STATE OF WASHINGTON  
**DEPARTMENT OF ECOLOGY**

**Re: Opinion pursuant to WAC 173-340-515(5) on Remedial Action for the following Hazardous Waste Site:**

- **Site Name:** Tye Aircraft McKechnie Group
- **Site Address:** 3008 100th Street SW, Everett, WA 98204
- **Facility/Site No.:** 91865744
- **Cleanup Site ID No.:** 1217
- **VCP Project No.:** NW2193

Enclosure A, Figure 3

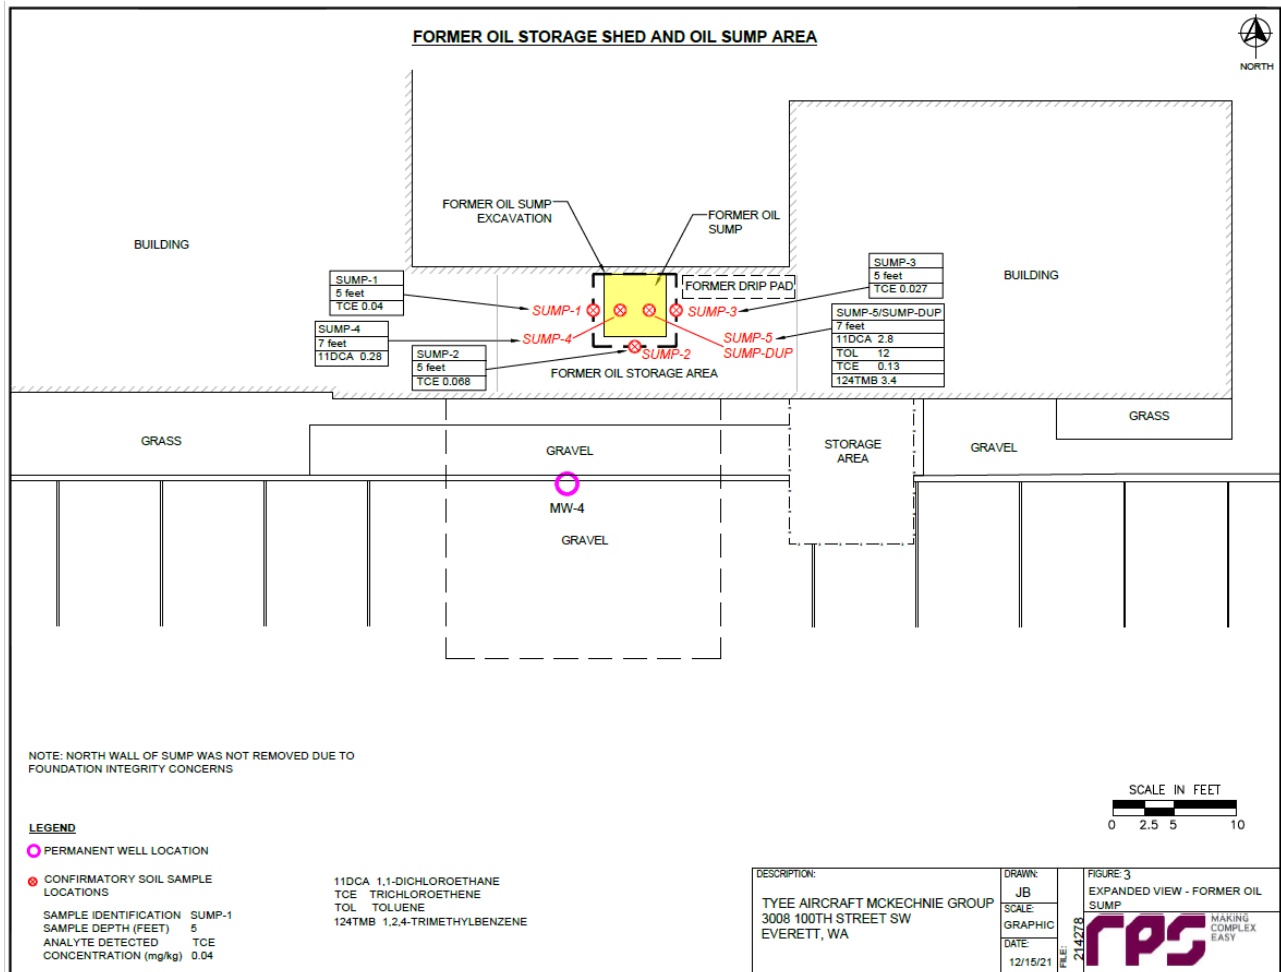
2. Confirmation soil sampling from the excavations indicate that the extent of contaminated soil

has not been characterized. MTCA requires that a cleanup action must use permanent solutions to the maximum extent practicable. Permanent solutions are actions in which cleanup standards can be met without further action being required, such as monitoring or institutional controls.

In this case, the contaminated soil is accessible and therefore should be remediated, which may require additional excavation. If soil amendments in the excavation is the proposed approach to remediating these contaminated soils, confirmation soil sampling would need to be completed that shows the remaining soils meet cleanup levels.

Confirmation soil sampling indicates that the contaminants of concern were remediated by means of excavation and/or injections to below cleanup levels in the following areas: Injection Area #1, Injection Area #2, TPH Excavation Area, and the former septic tank area. Confirmation soil sampling in the former oil sump cleanup area (located in the former oil storage area of the building) indicates that contaminated soils remain that exceed the Method A cleanup level for TCE (in samples Sump-1, Sump-2, Sump-5, and SB-103B), with one of the samples also exceeding the Method A cleanup level for toluene (Sump-5) (see **Figure 3**). The extent of contaminated soil in the former oil storage area has not been characterized.
